Version: January 3, 2025

**Oregon Supplement to the
Manual on Uniform
Traffic Control Devices
for Streets and Highways
11th Edition**

This is a compilation of draft proposals for the Oregon Supplement to the MUTCD 11th Edition as of the version date above. This is not official Oregon Supplement content. This is provided for information only. ODOT might edit final proposed language to fit with the scope and style of the Oregon Supplement to the MUTCD.

Figure 3B-16(OR). Examples of Yield and Stop Line Applications

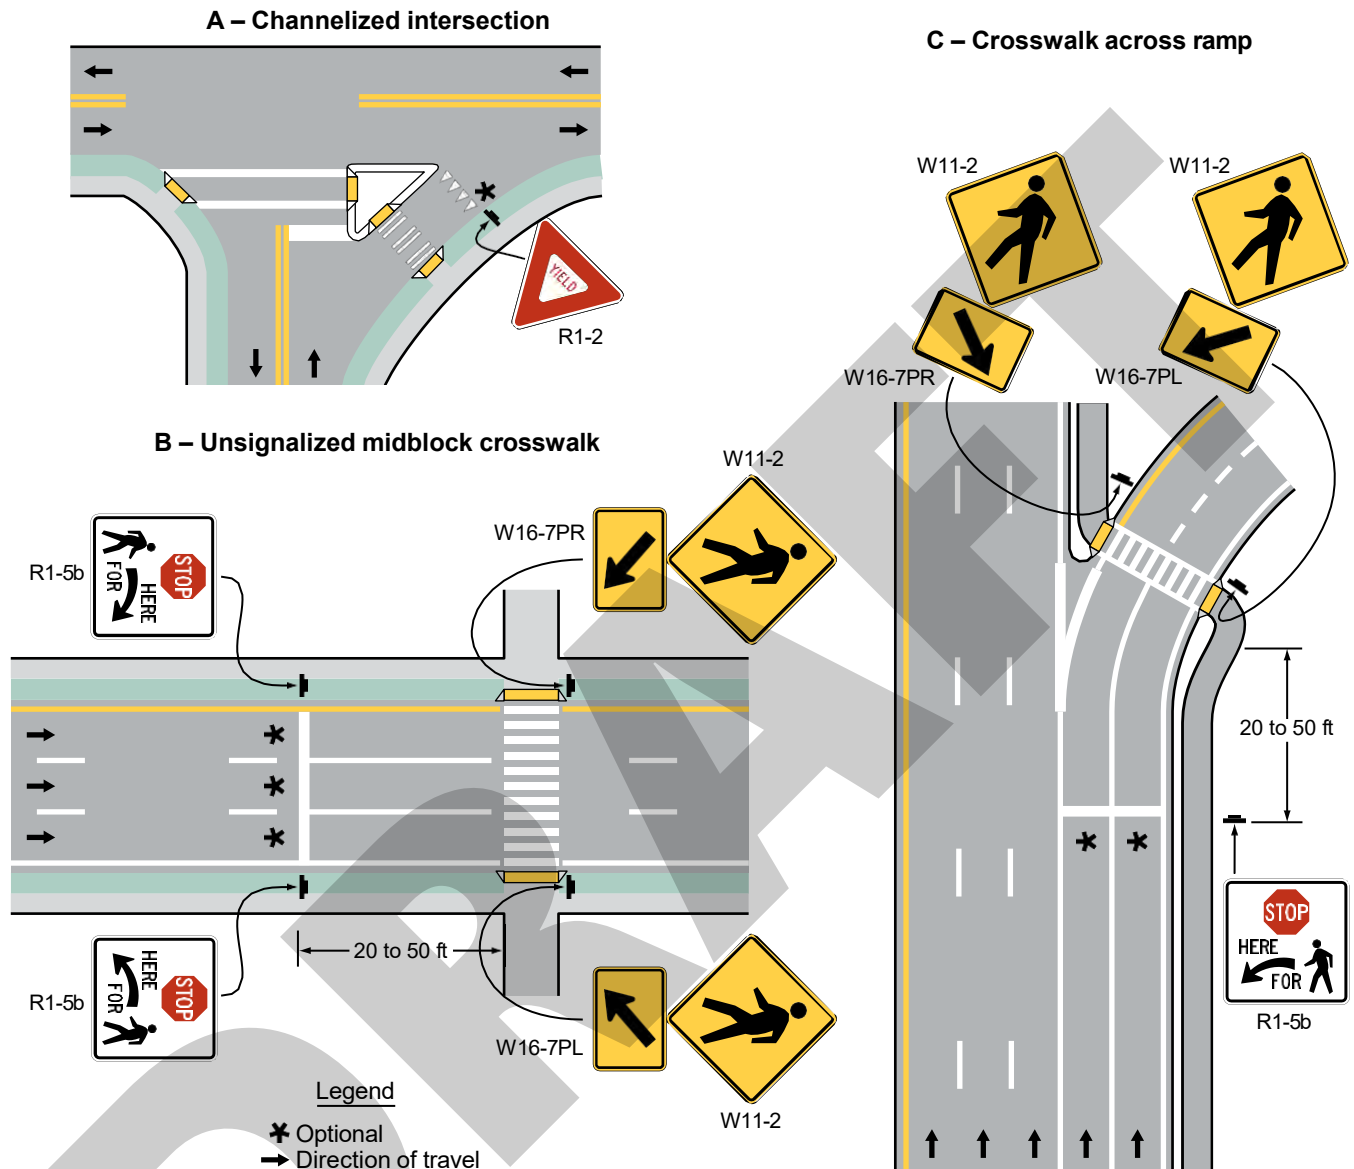
81 13a *If a yield line is used at channelized-right turn lane with a marked crosswalk, the yield line should be*
82 *placed beyond the marked crosswalk (see Drawing A in Figure 3B-16(OR)).*

Figure 3B-14(OR). Examples of Applications of Lane-Reduction Transition Markings

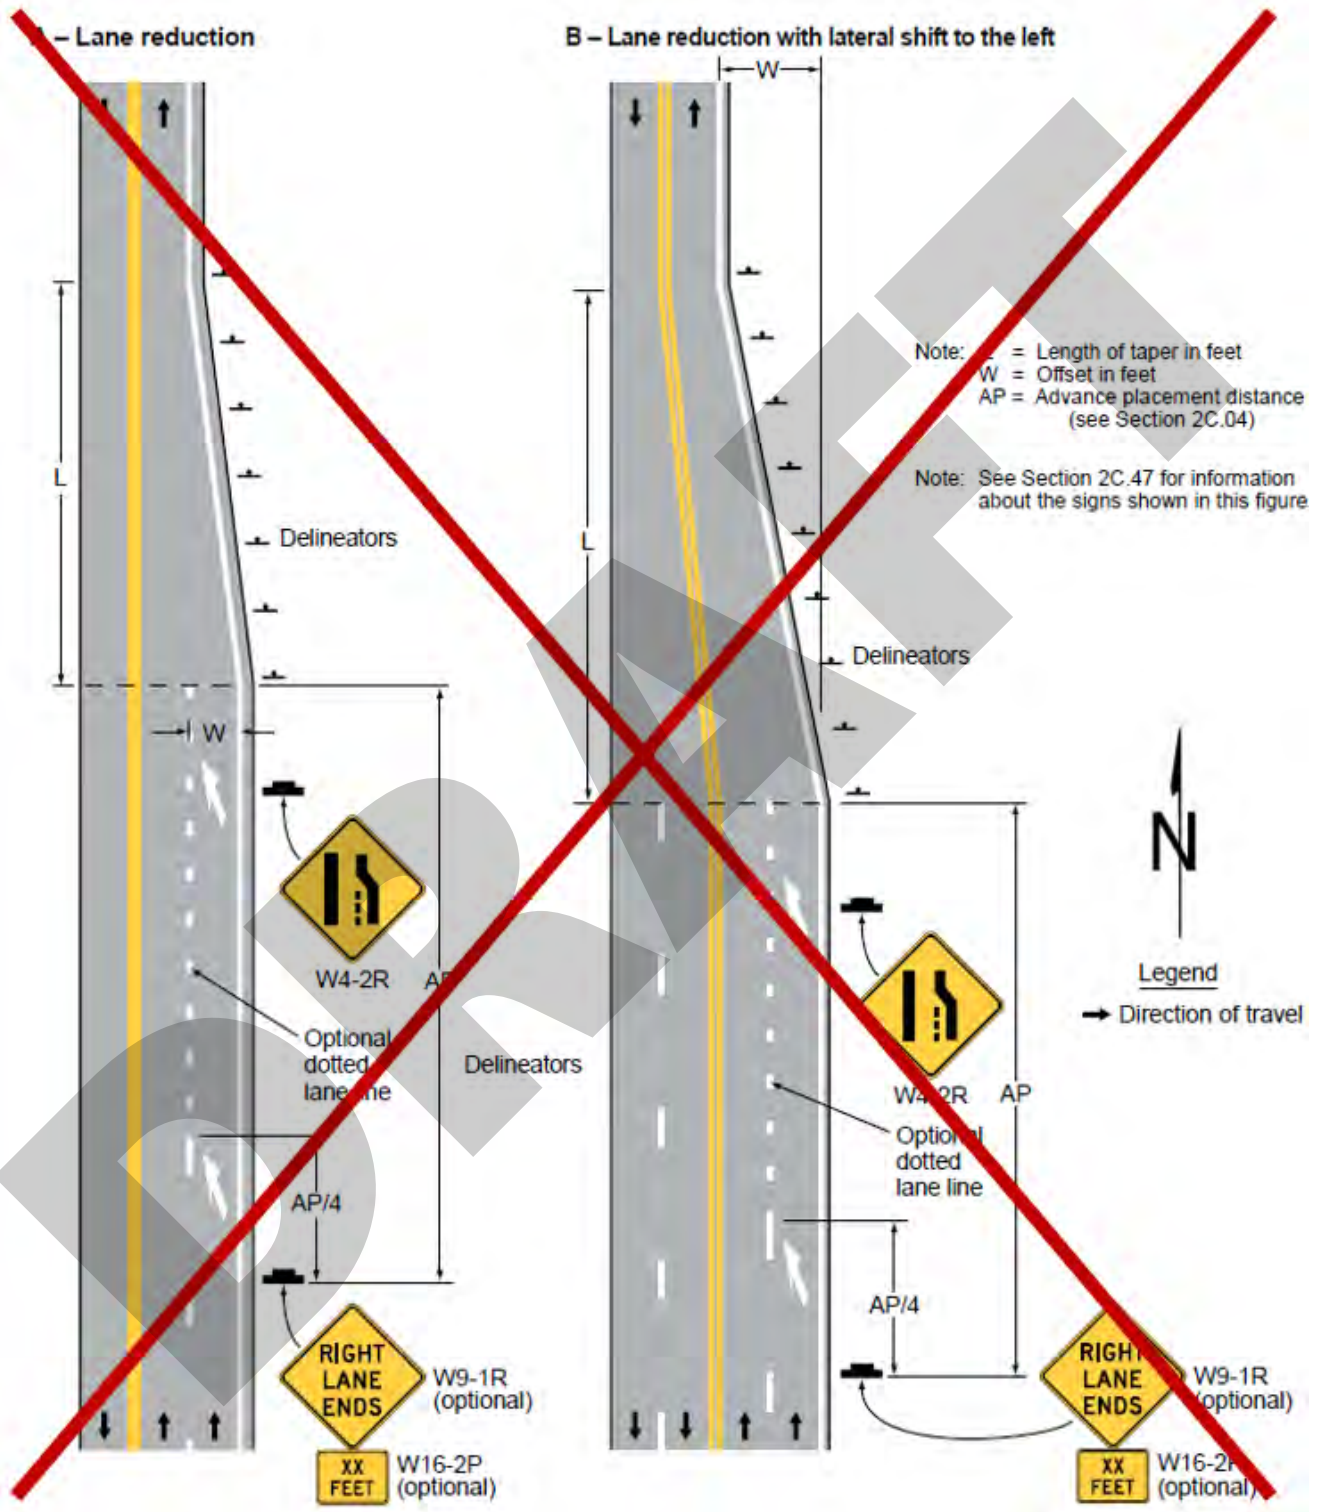
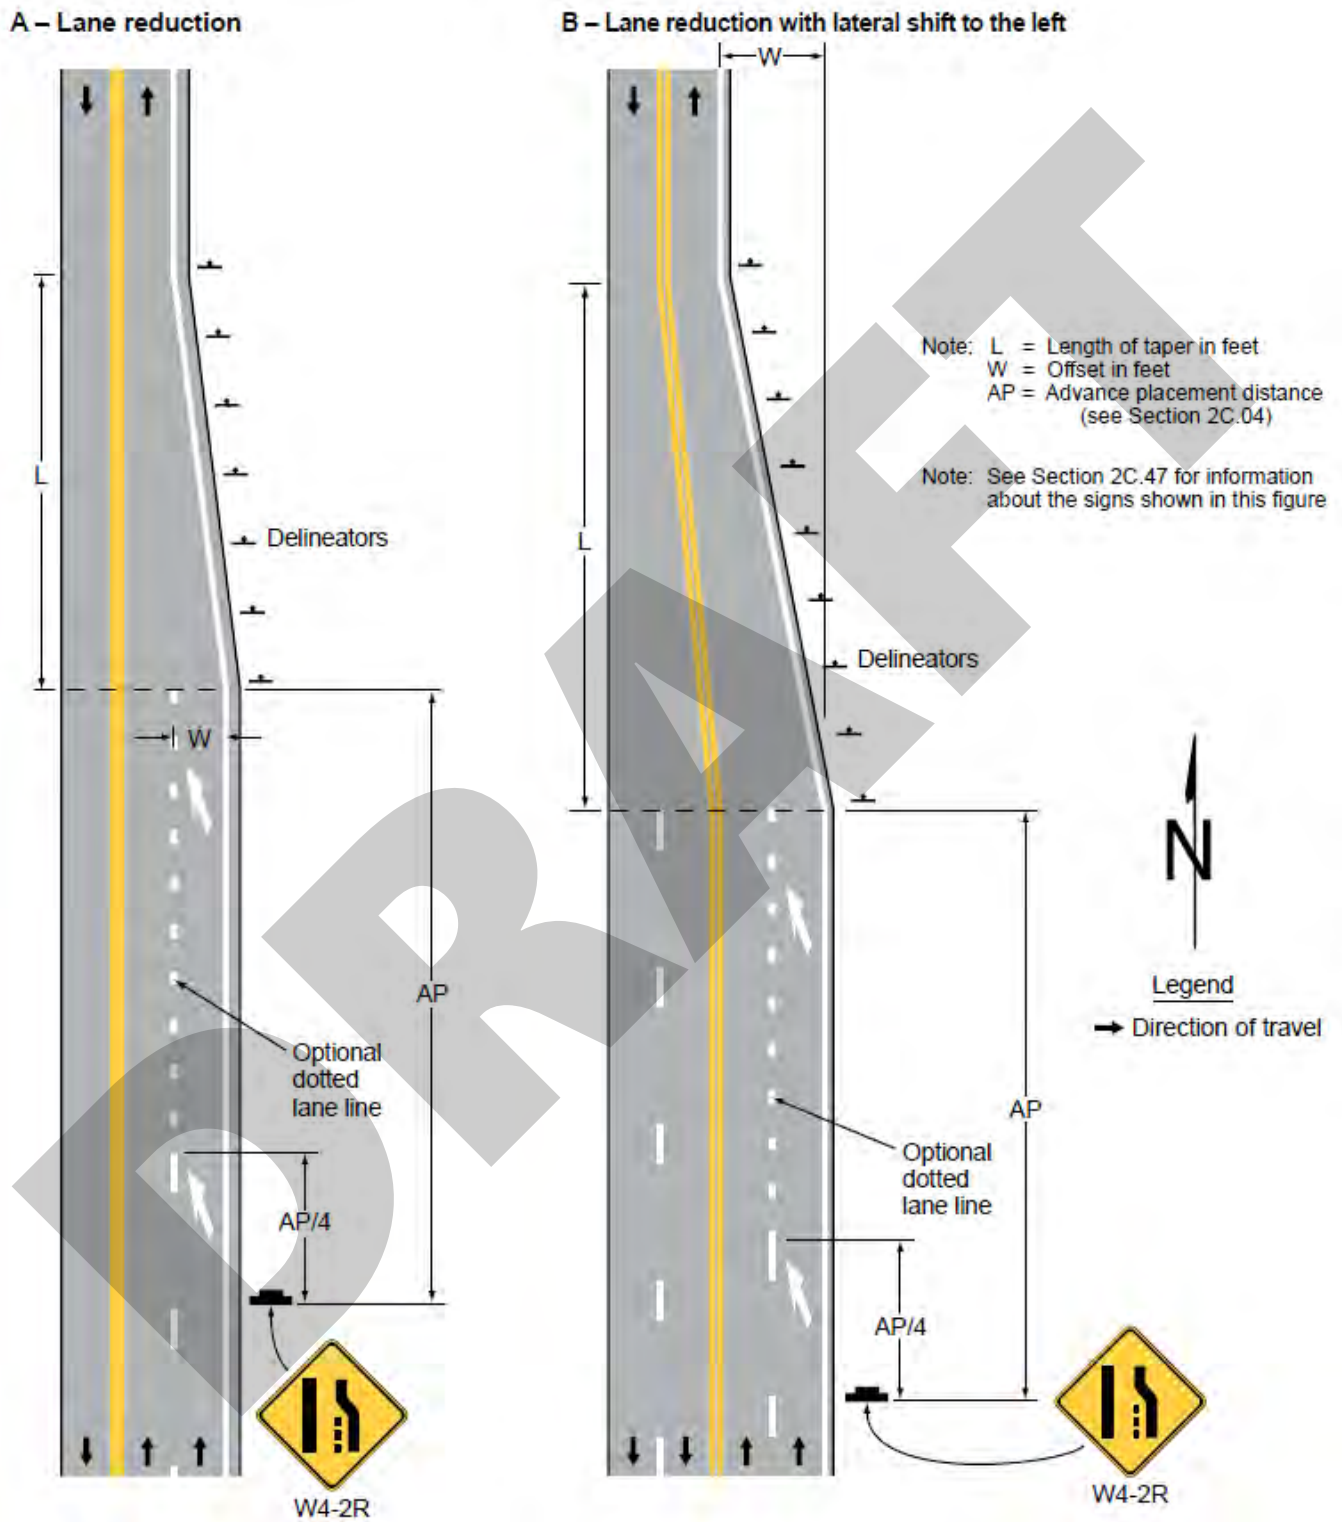
2 Figure 3B-14 in Section 3B.12 Lane Reduction Transitions is on FHWA’s known error list. In Figure 3B-
3 14 the sign assembly is in the incorrect location. This can lead to incorrect sign placement at lane
4 reductions if the Supplement does not address it.

6 FHWA published the know errors of the 11th Edition of the MUTCD. This proposes to address the
7 known error of the sign placement in Figure 3B-14. The placement of sign W4-2R in Figure 3B-14
8 moved to the correct location.

Figure 4I-5(OR). Pedestrian WALK Interval and Flashing Yellow Arrow Signal Face

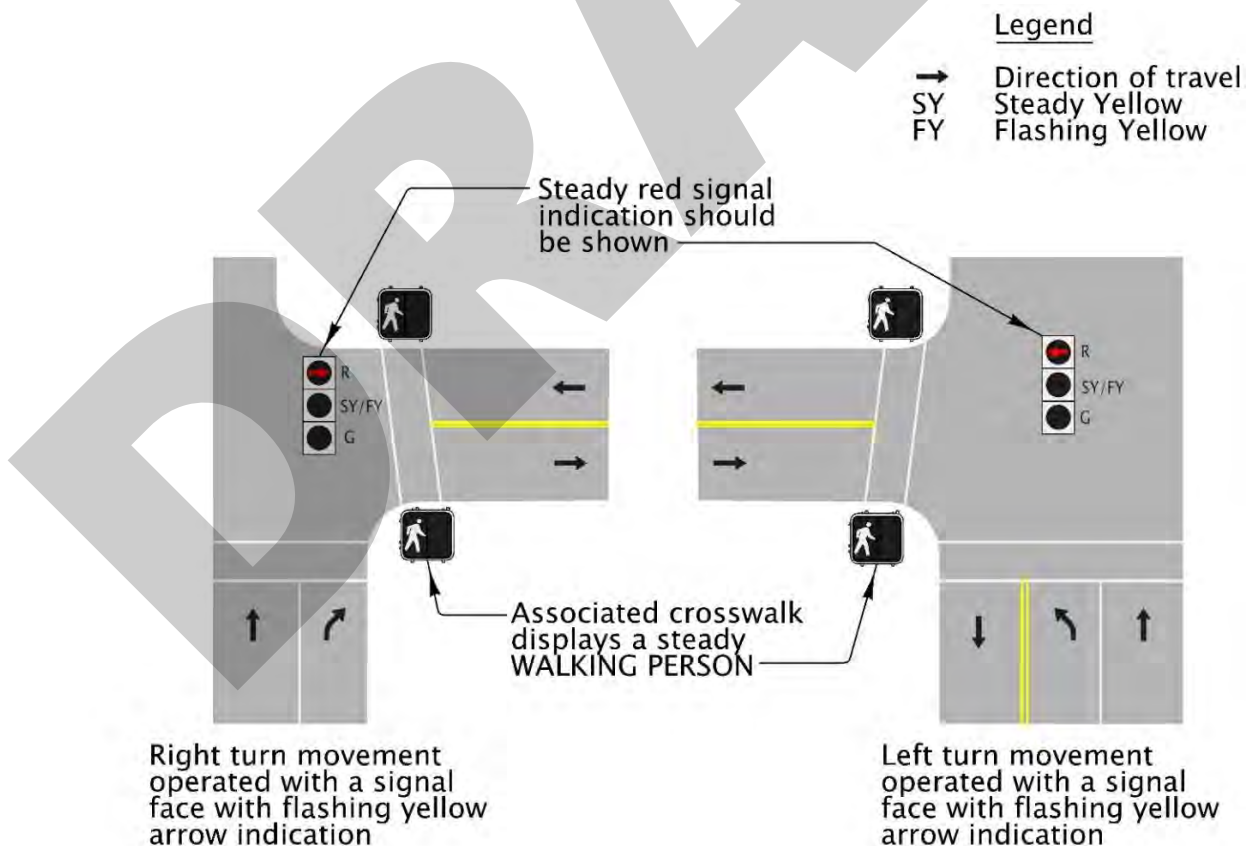
02a When the pedestrian signal heads with an associated crosswalk are displaying a steady WALKING PERSON (symbolizing WALK) signal indication, a steady red signal indication should be shown to any left turn and right turn movement that is operated with a signal face with Flashing Yellow Arrow indication. See Figure 4I-5(OR).

Figure 8B-8(OR). Private Crossing Sign

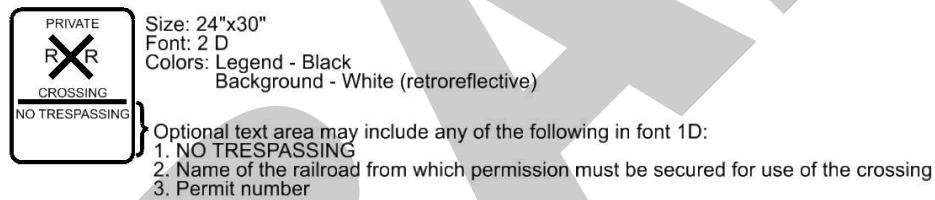
01 Private crossings, including farm crossings, that are not equipped with flashing light signals or automatic gates shall install a STOP (R1-1) sign with private crossing sign (see Figure 8B-8(OR)) on each side of the crossing as shown in Figure 8B-9(OR).

Figure 8D-3(OR). Legacy Light Rail Transit and BRT Signal Indications

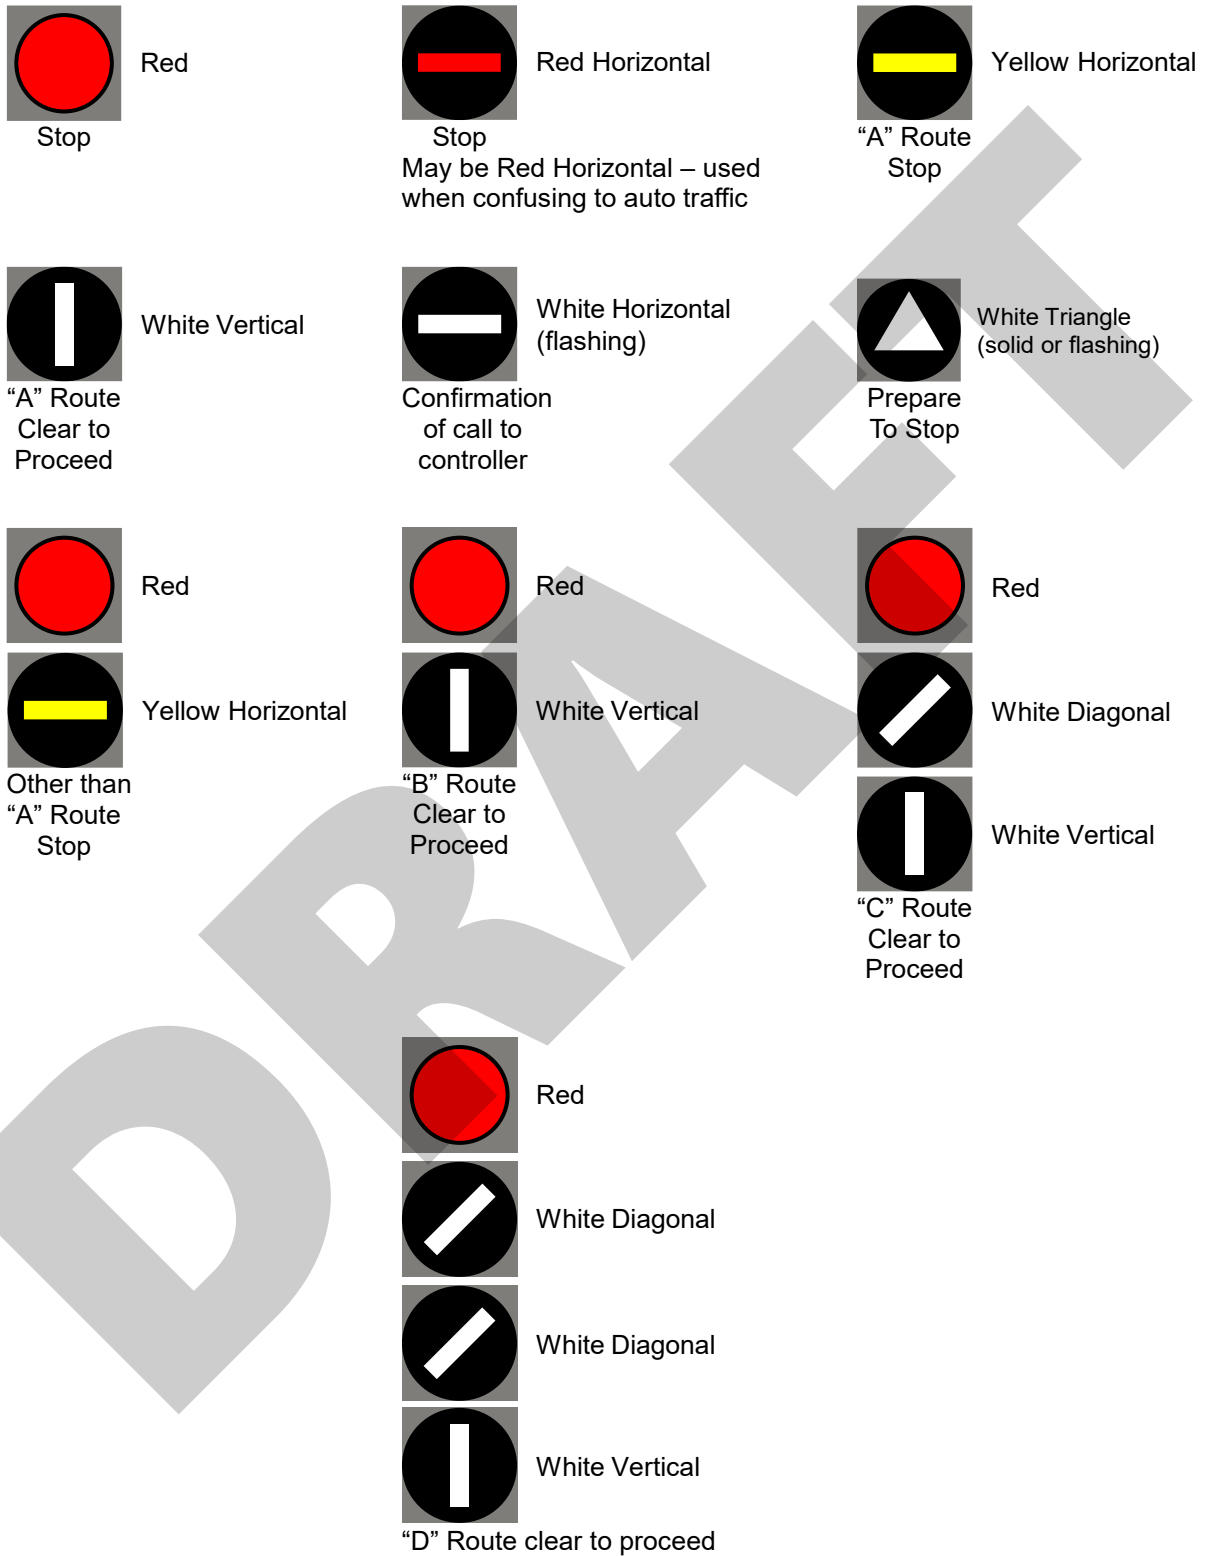
43 05b Figures 8D-3(OR) through 8D-7(OR) illustrate TriMet standards for LRT traffic control that were
44 developed prior to their inclusion in the MUTCD, follow national LRT standards, and are used extensively
45 throughout the Portland Metropolitan area. The white flashing triangle used per the 2009 MUTCD Figure
46 8C-3 also remains an acceptable symbol to use for existing legacy systems. However, replacement of
47 existing legacy signal indications according to figure 8D-C should be considered when feasible.

20 **Figure 2: MUTCD 11th Edition, Figure 8B-2**

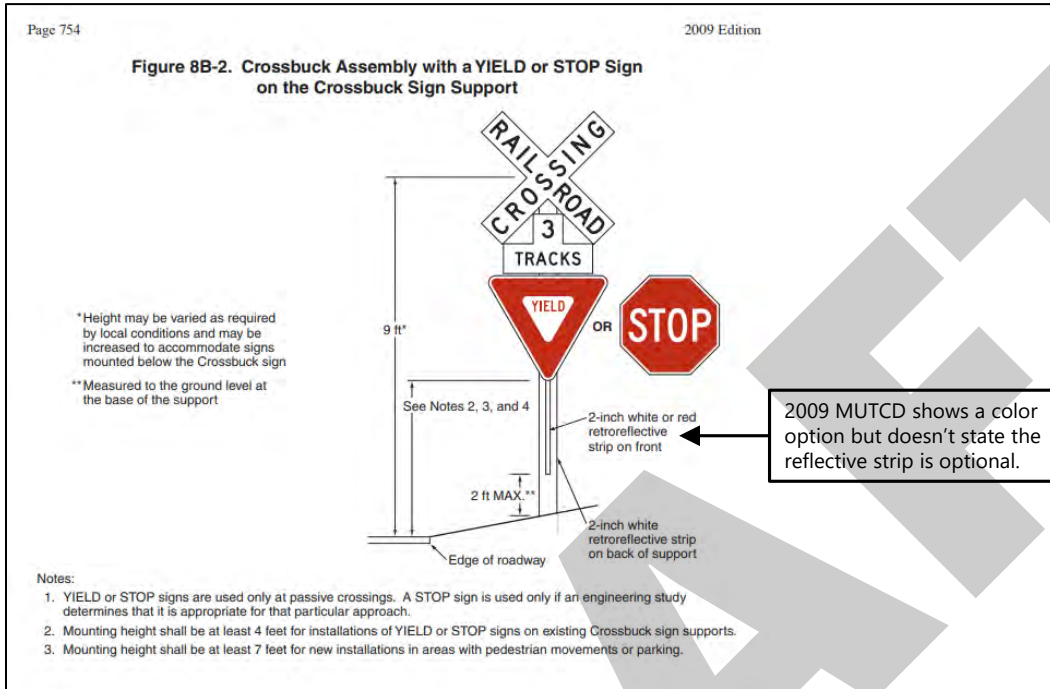
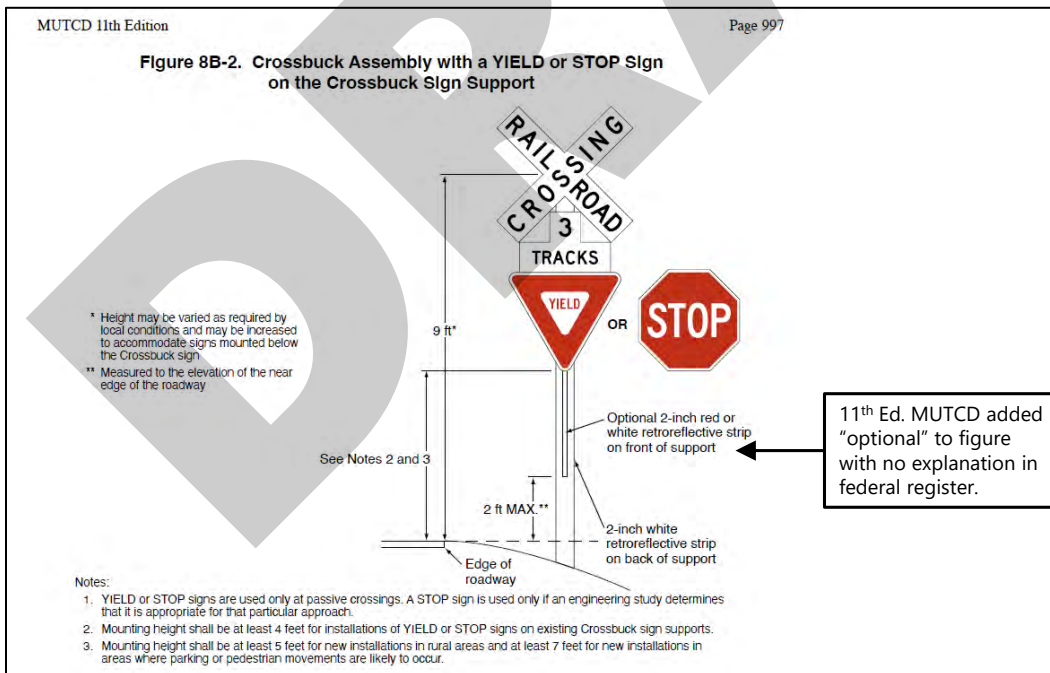
2 Figure 8B-2 in the 11th Edition is not clear on whether a reflective strip is required or optional
3 (regardless of the color used).
